TAP Information No 20 - August 2014

Vacuum Motor Appearance Change

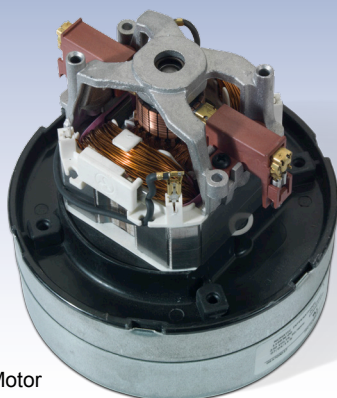
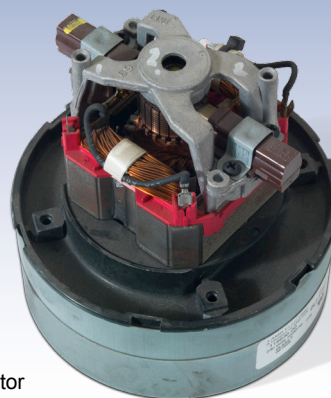
Numatic International have moved production of their vacuum motors from North America to Europe. This will not affect performance but the look of the motor has changed for the 1200W version, in the future you will be required to order a different part number for the carbon brush on the 205403 240V DL2 1104T 1200W model.

Dry Motor Range Serial number starting at 1307

Wet Motor Range Serial numbers starting at 1308

Important: Please note that when using the chart above for ordering replacement carbon brushes for the (205403) DL2 1104T 1200W, ensure you use the serial number of the machine to order the correct parts.
